RE: Shepard Development LLC - Site Plan Review and Variances – Files #15-007994 and 15-022204

NPS COMMENTS

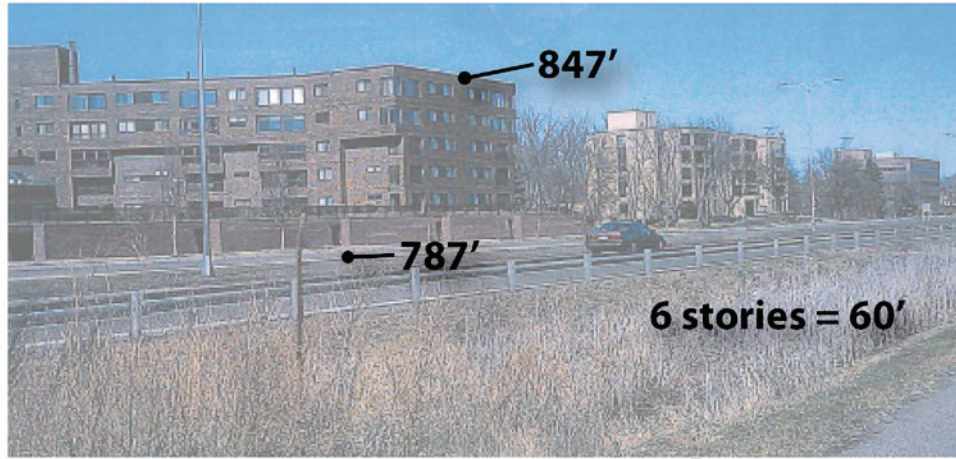
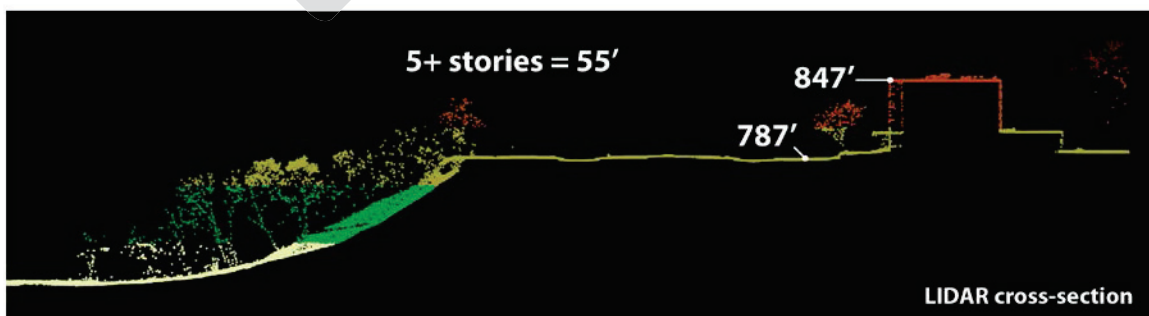
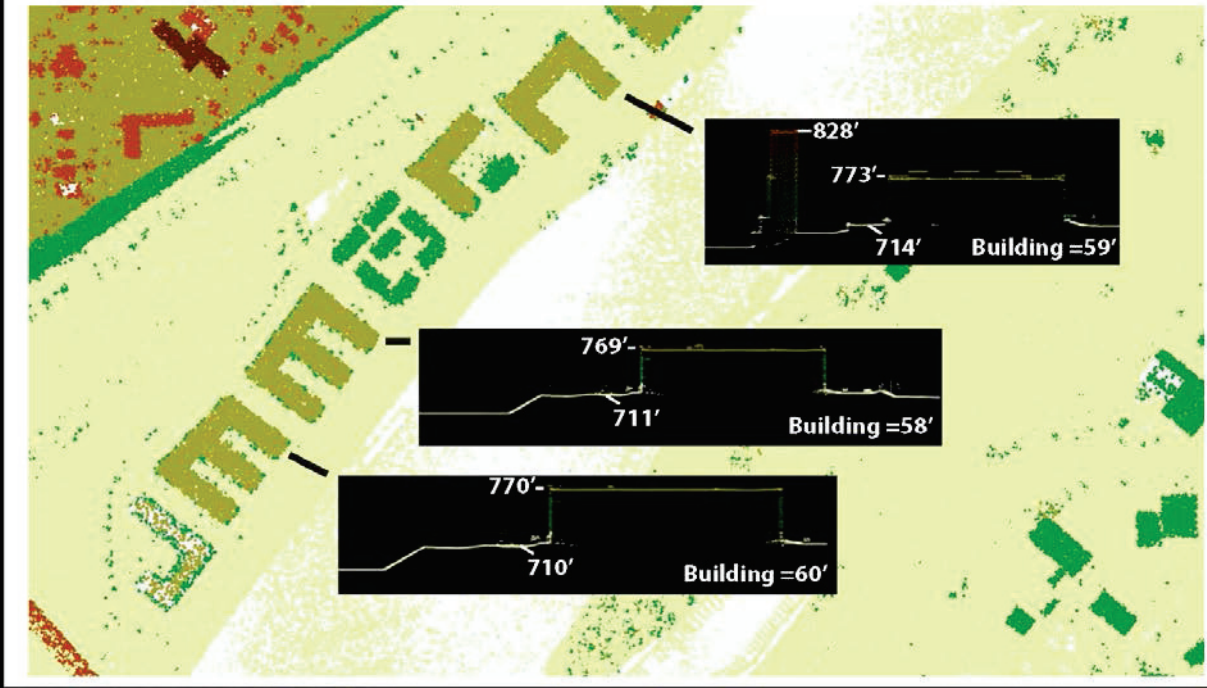
We do not find the other apartments identified along Shepard Road to be comparable to this proposal however. Number of stories, not building height, is used to justify the comparisons which can be misleading. We analyzed the building heights of the compared buildings based on available LIDAR data. That analysis is below.

The proposed 73' building is up to 25% larger than the apartments that are used to justify the additional height. That is not comparable. This again emphasizes how the use of floors/stories is misleading.
